SERVICE BULLETIN BOOK

1990

WMS GAMES

**WILLIAMS ELECTRONICS GAMES, INC.
MIDWAY MANUFACTURING COMPANY
*MAKERS OF WILLIAMS AND BALLY AMUSEMENT GAMES***

Figure 1. 3-Bank Drop Target Opto Board

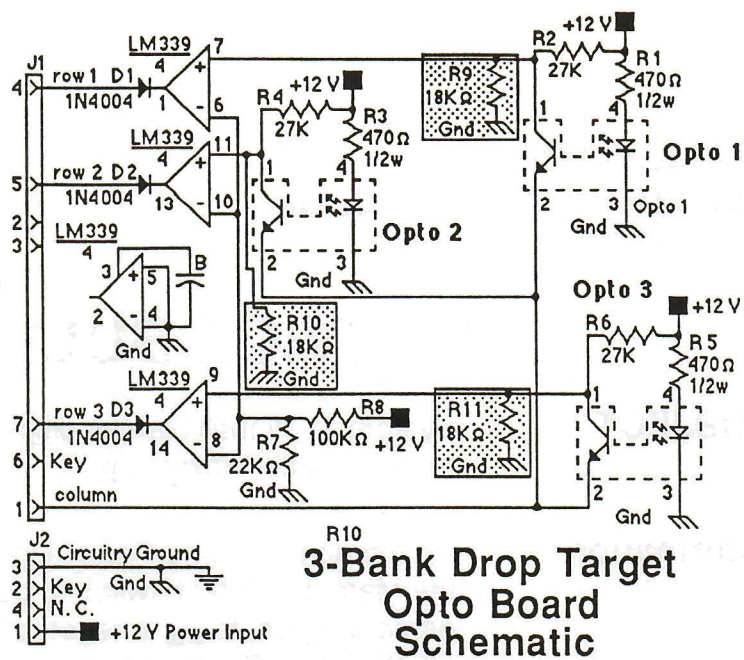
SUBJECT: Solution of possible problems with 3-Bank Drop Target Opto Boards. Problems may include (a) unexpected TILTS or (b) unearned CREDITS.

1. Make sure that the plugs on connectors J1 and J2 of the Opto Board are making proper electrical connections.
2. Check to verify that each of the three 1N4004 diodes (for noise suppression and blocking) on the 3-Bank Opto Board is functioning properly. (See Figure 1.) The cathodes of these diodes connect to the outputs of IC1 (Pins 1, 13, and 14), and the anodes connect to, respectively, Pins 4, 5, and 7 of J1.

For older Opto Boards (C-11318-1) experiencing the problems mentioned above, these diodes can be added, using the proper technique, as follows:

- (A) Cut the circuit board trace between IC pin 1 and J1-4. Connect (solder) the anode of a 1N4004 diode to the trace connected to J1-4. Connect (solder) the cathode of that 1N4004 diode to the trace connected to IC pin 1.
- (B) Cut the circuit board trace between IC pin 13 and J1-5. Connect (solder) the anode of a 1N4004 diode to the trace connected to J1-5. Connect (solder) the cathode of that 1N4004 diode to the trace connected to IC pin 13.
- (C) Cut the circuit board trace between IC pin 14 and J1-7. Connect (solder) the anode of a 1N4004 diode to the trace connected to J1-7. Connect (solder) the cathode of that 1N4004 diode to the trace connected to IC pin 14.

Figure 1. Inner View of Coin Door Showing Installation.

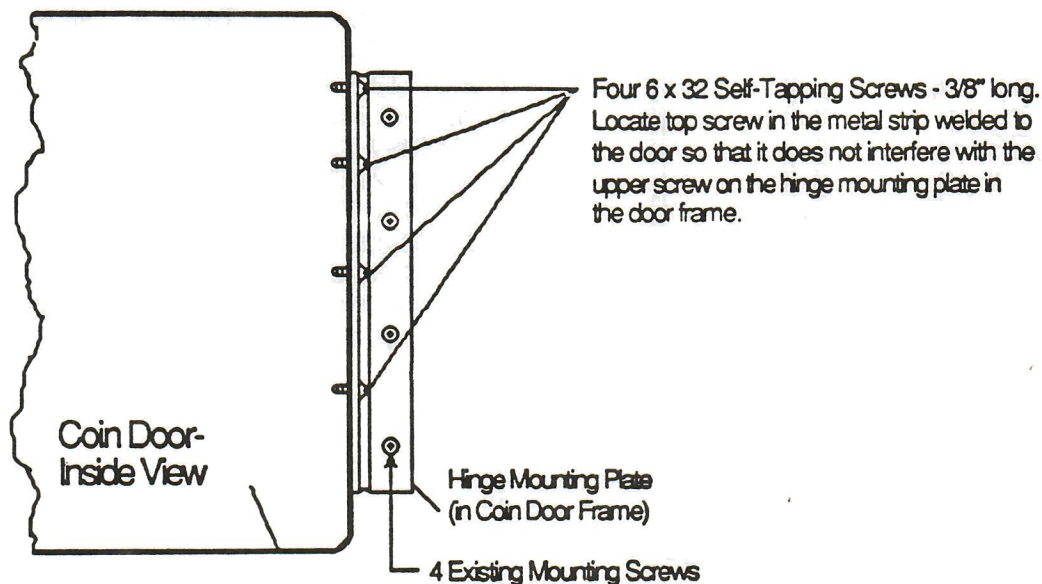
SUBJECT: Solution of possible problems with welded Hinge Mounting Plate of the Coin Door.

1. Open the Coin Door fully to permit access to welded Hinge Mounting Plate of the Coin Door.
2. Drill four holes in the approximate locations shown in Figure 1, using a #32 (0.116 in.) drill bit. Note that the upper hole must be located so that the screw to be installed does NOT interfere with the top mounting screw on the door frame Hinge Mounting Plate.
3. Install four 6-32 Self-Tapping screws - 3/8" long in the drilled holes. Tighten them securely to provide maximum assurance against separation of the weld on the Hinge Mounting Plate.

SPINNING TARGET ASSEMBLY B-12785

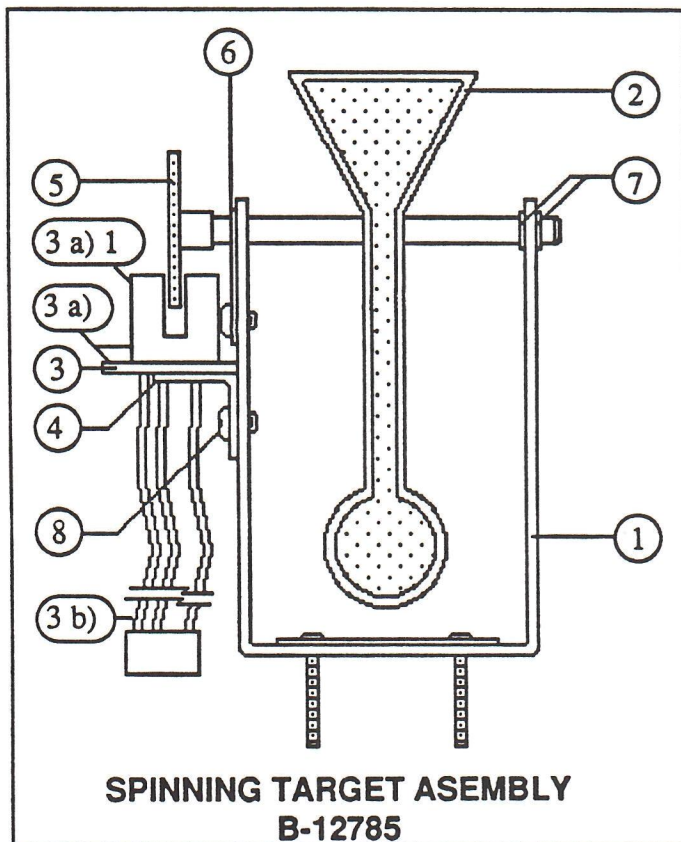
SUBJECT: Corrected Parts List and Illustration for **POLICE FORCE** Spinning Target Assembly

Information: Please correct the Parts List and Illustration, on page 58 of your game manual, for the Spinning Target Assembly, p/n B-12785. (The callouts in the game manual are incorrect. We are also adding the part number for the Optotransistor, mounted on the Opto Switch & Cable Assembly.)

SUBJECT: ROLLER GAMES "Deep Freeze" Magnet Performance Adjustments

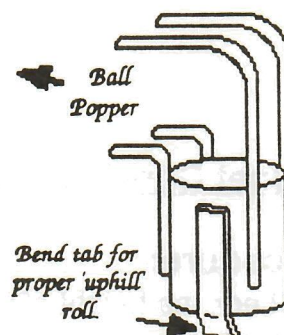
Information: Three adjustments are recommended, to ensure proper "Deep Freeze" Magnet operation. Determine which is applicable for your game. (Some games may need only one; some may need more than one.)

The first adjustment affects the ball direction, as it exits the tube at the end of the Ball Popper Wire Ramp. The second adjustment affects the ball location when 'frozen' by the magnet. The third adjustment affects the magnet core height.

1. Check the direction and distance of ball movement as it exits the Ball Popper Wire Ramp tube. As it drops out of the tube, the tab at the bottom of the tube should send the ball rolling 'uphill' (upward on the playfield) approximately 1 inch, before rolling down the ball guide into the "Deep Freeze" Magnet region, near the Upper Right Flipper.
2. Adjust the tab at the lower end of the Ramp tube to obtain the proper 'uphill' roll. Be careful of the 'uphill' roll distance because too long an 'uphill' roll can cause the ball to gain too much momentum and roll completely through the magnet area too fast for the magnet to 'freeze' (hold) it. Also, be careful of the direction of the roll. The tab should direct the ball slightly toward the ball guide to ensure that the ball will roll through the magnet region, rather than possibly bouncing away from the magnet region.

Ball resting on Upper Right Flipper rubber, during Magnet 'Freeze'

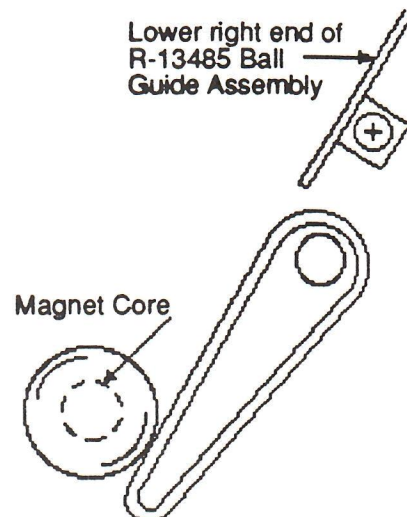
Upper Right Flipper Paddle Adjustment

1. Check the ball movement as the magnet 'freezes' (holds) it. Ideally, the ball will be rubbing on the red flipper rubber, during the 'freeze'. This dampens the magnetic oscillations much faster and allows a well-aligned shot up the left Upper Plastic Ramp.
2. Adjust the Upper Right Flipper paddle position, if possible, to allow the ball to rest on the red flipper rubber, while the magnet is holding it.
3. Be careful during this adjustment to **avoid** making the "loop" shot around the ball guide at the top of the playfield end in an 'outhole' drain (up the left side of the ball guide, around the upper rim, and down the right side of the ball guide, past the flipper paddle, and down between both lower flippers into the outhole). The Upper Right Flipper paddle should send the ball onto the lower right flipper, when properly adjusted.

Magnet Core Height Adjustment

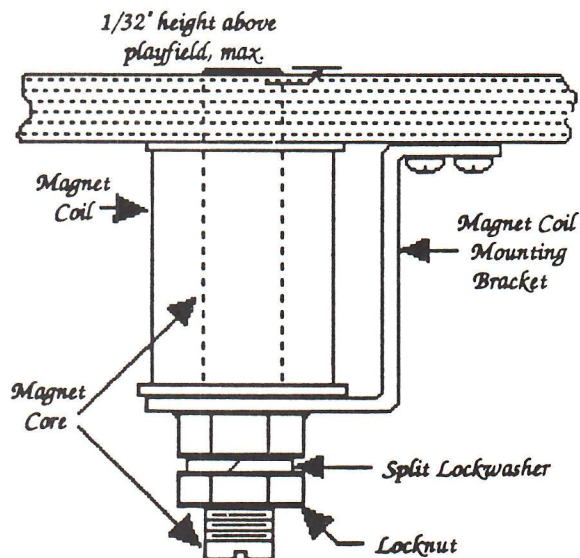
1. Check the height of the metal "Deep Freeze" magnet core above the playfield surface. The optimum height is approximately $1/32$ ". This height causes the ball to "freeze" faster, by reducing the speed of the ball movement, yet it does not apparently interfere with other shots.
2. Raise the playfield to allow a straight-bladed screwdriver blade to turn the core for the proper height. If necessary, slightly loosen the locknut securing the core in its bracket. Retighten the locknut following the height adjustment to secure the core at the desired height.

Shooter Lane Exit Path Adjustment

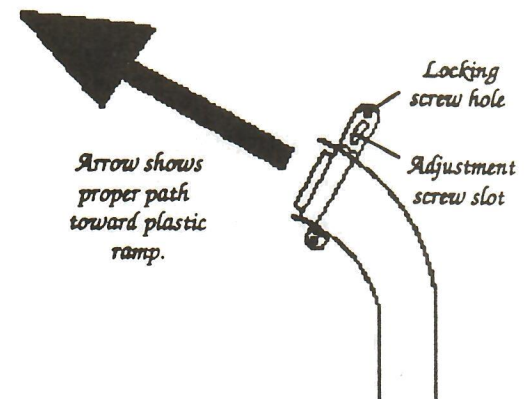
Information: As the ball exits the shooter lane, it should proceed across the playfield and go up the plastic ramp (as shown by the dark arrow). Adjustment of the shooter lane ball guide may be necessary to obtain this ramp shot.

1. Check the ball trajectory (path) from the shooter lane ball guide toward the plastic ramp. The ball should move smoothly up the ramp entrance.
2. If necessary, loosen the ball guide screw in the ball guide slot, and reposition the ramp to obtain the proper ramp entry.
3. To maintain the ball guide position, install another screw in the Locking Screw hole.

Upper Diverter Assembly
p/n C-13489 , Rev. C

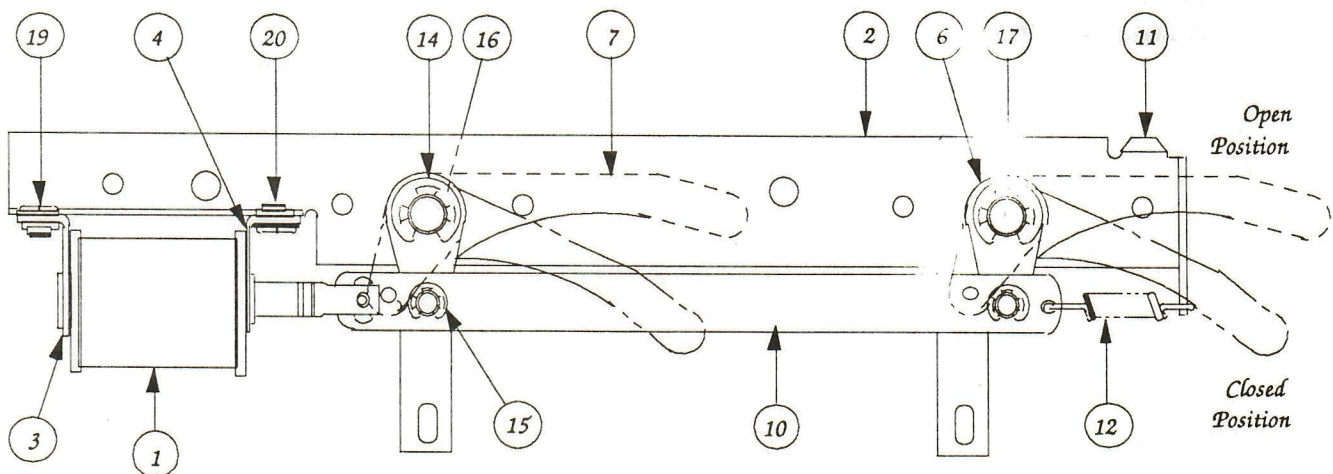
SUBJECT: ROLLERGAMES Upper Diverter Assembly Improvements

Information: Improvements to the Upper Diverter Assembly, p/n C-13489, include (1) a coil change (replace the AE-23-800 coil with one marked AE-26-1200); (2) a Solenoid Bracket Assembly, p/n B-13488, change; and (3) a change to the assembly comprising the coil plunger, drive link, and spring.

It is suggested that these changes can occur in the order listed in the preceding paragraph; that is, coil replacement should be first, followed by replacing the Solenoid Bracket Assembly. If necessary, the more complex change of the coil plunger, drive link, and spring should resolve all associated problems with the Upper Diverter Assembly.

- A. Unsolder the wires connected to the Coil, noting each wire's coil terminal.
- B. Remove the solenoid bracket Mounting Screws (19), retaining them for reassembly.
- C. Remove the AE-23-800 Coil (1), and replace it with an AE-26-1200 Coil.
- D. Replace the Solenoid Bracket Assembly, p/n B-13488, (3) with a new 'revision A' Assembly. (The revision A Solenoid Bracket Assembly has a slightly shorter solenoid stop than the original assembly.)
- E. Mount the Coil (1) and Solenoid Bracket Assembly (3), as they were on the original unit; install and tighten the bracket Mounting Screws (19), using Loc-Tite.
- F. Solder the wires to the new Coil, connecting them to the proper terminals (noted in step A).

- A. Remove the two "E" Rings attaching the old Diverter Drive Link to the two black, plastic Arm Assemblies; retain these "E" Rings for reassembly.
- B. Remove the spring at the end of the old Drive Link; remove the old Drive Link, including the spring-attached Coil Plunger.

- C. Replace all of the old Drive Link parts (coil plunger, springs, etc.) with the new Link-Plunger-Spring Assembly (10), p/n B-13843, sliding the plunger into the coil and inserting the post of each Arm Assembly (7) into the proper hole of the new Link-Plunger-Spring Assembly.
- D. Attach an "E" Ring on each Arm Assembly post to reassemble the Link-Plunger-Spring Assembly. Slip the loop of the Spring into the hole of the Diverter bracket, where the old spring was removed.
- E. Move the updated Diverter Assembly back and forth several times to verify that it is moving freely, without binding. If necessary, apply a small amount of Williams' Drop Target Grease (or similar lubricant) to the rotating posts on each Arm Assembly.
